Comment for Cross-matrix

TFVS#6

JASIC

Proposal for a Sound Emission Regulation Cross Matrix

D. Sound Sources

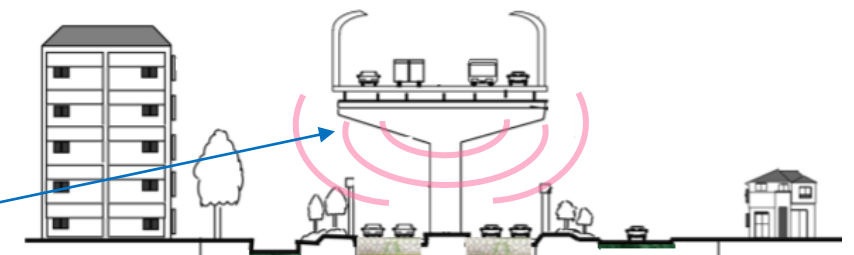
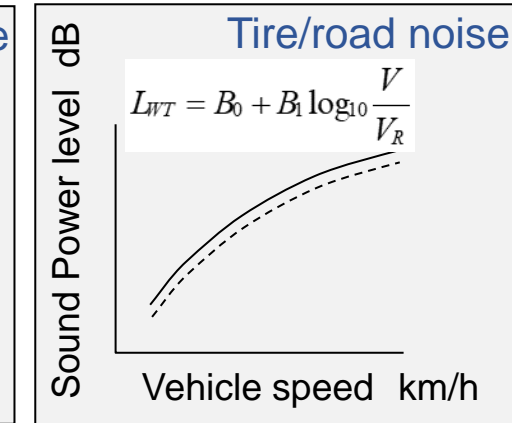
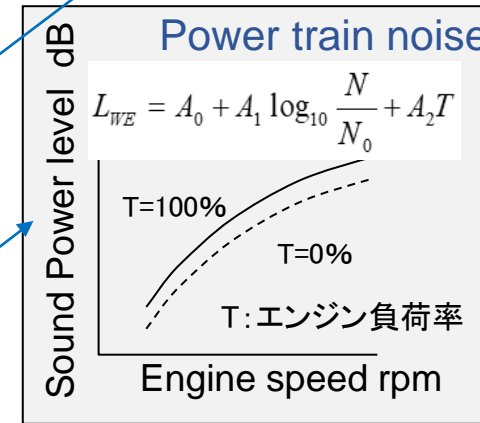
Should be added
